Attachment D

Submissions

From: Paul Gallant <[REDACTED]> on behalf of Paul Gallant <[REDACTED]> <Paul Gallant <[REDACTED]>
Sent on: Sunday, November 23, 2025 12:06:59 PM
To: dasubmissions@cityofsydney.nsw.gov.au
Subject: Submission - D/2025/1144 - 96 Hay Street HAYMARKET NSW 2000 - Attention Adrian McKeown

1 SHADOW DIAGRAM - JUNE 21 9AM

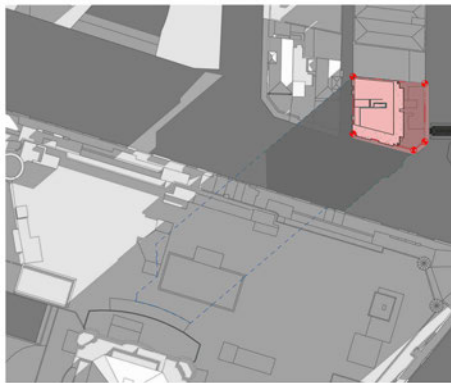
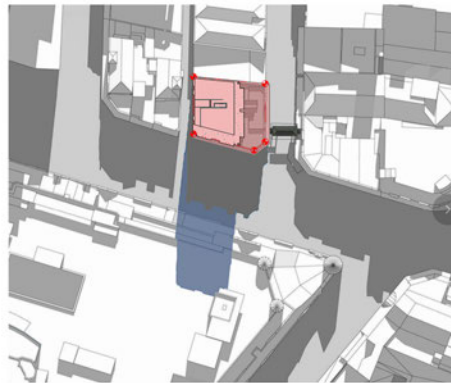
The developers Clause 4.6 variation requests a height allowance of 54.87m, exceeding the 50m limit. Most importantly, the overshadowing of our level 6 Recreational Facilities in Winter is very significant (see diagrams).

Our Children's playground, BBQ area and Jogging track are completely overshadowed at 9am in winter which also reduces direct and ambient light into our Pool and gym areas!

According to the 21 June at 12 noon overshadowing diagram on page 22 of the same document, the above statement is fundamentally WRONG.

The proposed new development is the sole cause of the 12 noon overshadowing of our level 6 Podium area of The Peak Apartments. This area contains a communal garden and recreation facilities used by residents and guests of the 377 apartments.

If the new development proceeds without modification, and in particular if it exceeds the 50m height guideline, there will be no time of day on 21 June in which the podium area isn't overshadowed by one or more buildings. We therefore submit that not only should the new development not be allowed to exceed 50m height; it should NOT be approved to be of a height which overshadows the Peak's podium area at all from 12 noon on 21 June. Additional shadow modelling is required to calculate what lower height that should be?

1 SHADOW DIAGRAM - JUNE 21 9AM

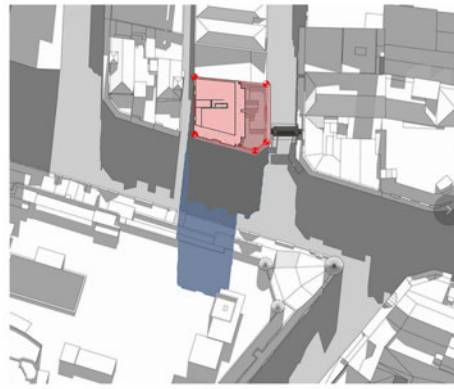
The developers Clause 4.6 variation requests a height allowance of 54.87m, exceeding the 50m limit. Most importantly, the overshadowing of our level 6 Recreational Facilities in Winter is very significant (see diagrams).

Our Children's playground, BBQ area and Jogging track are completely overshadowed at 9am in winter which also reduces direct and ambient light into our Pool and gym areas!

According to the 21 June at 12 noon overshadowing diagram on page 22 of the same document, the above statement is fundamentally WRONG.

The proposed new development is the sole cause of the 12 noon overshadowing of our level 6 Podium area of The Peak Apartments. This area contains a communal garden and recreation facilities used by residents and guests of the 377 apartments.

If the new development proceeds without modification, and in particular if it exceeds the 50m height guideline, there will be no time of day on 21 June in which the podium area isn't overshadowed by one or more buildings. We therefore submit that not only should the new development not be allowed to exceed 50m height; it should NOT be approved to be of a height which overshadows the Peak's podium area at all from 12 noon on 21 June. Additional shadow modelling is required to calculate what lower height that should be?
